RE: Whetstone Park Type 3 Stream Corridor Protection Zone (SCPZ) Variance Request
Comments

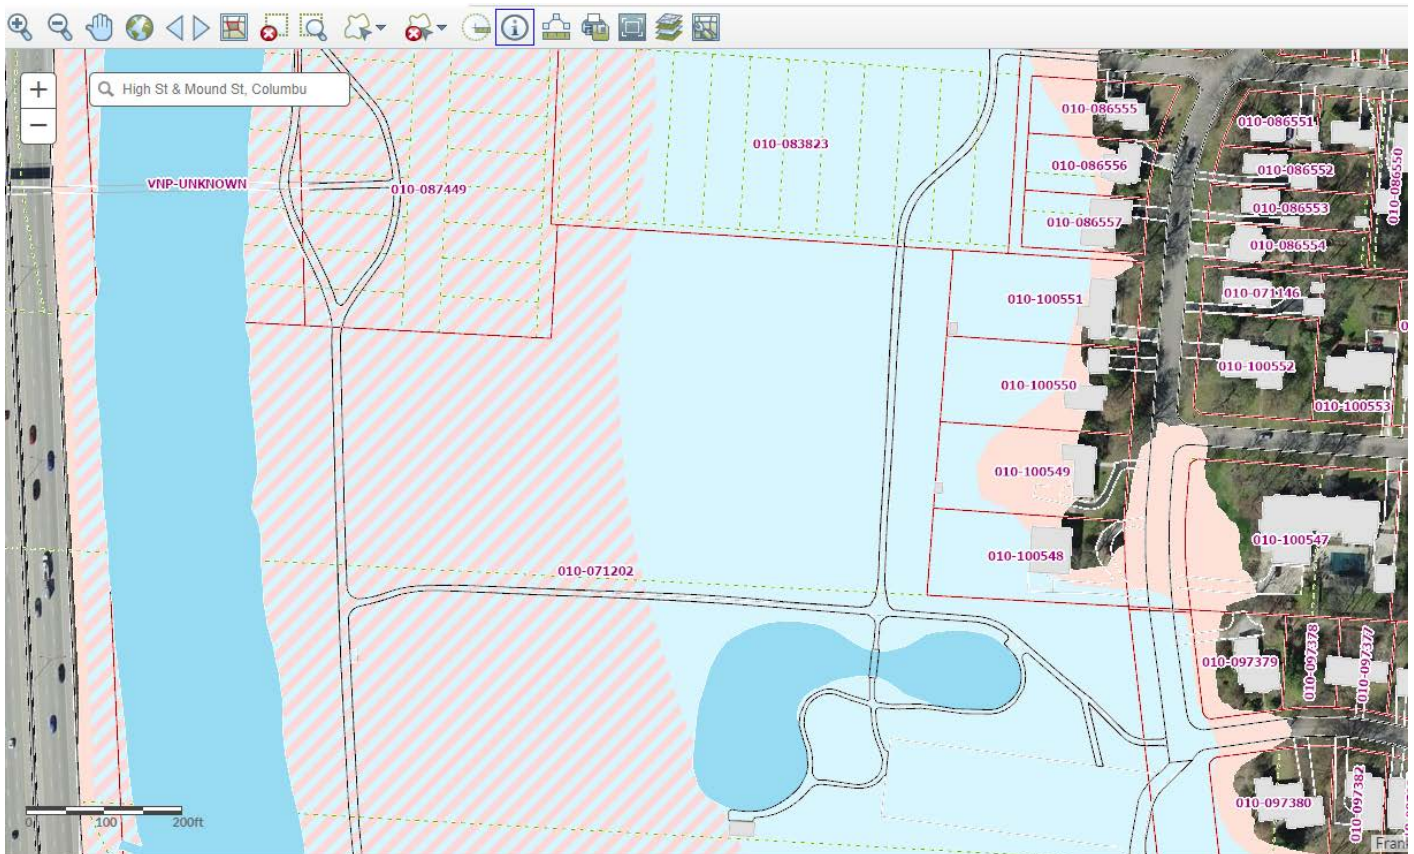
The image below depicts the USGS StreamStats subwatershed basin for the small stream just south of the Project Area in Whetstone Park. StreamStats is often inaccurate in urban areas. Can you calculate the SCPZ based on the sewershed please?

According to USGS' Stream Stats, the small stream and pond south of the project area have a drainage basin of 0.11 acres (a minimum of 24 FT SCPZ). Has the applicant taken this into account in the exhibit drawings? Has the pond been include in the SCPZ? **The small stream to the south has a minimum SCPZ width of 50 ft. per SWDM 1.3.1, and, therefore, is outside the limits of the project. Columbus DOSD does not apply SCPZ requirements to ponds.**
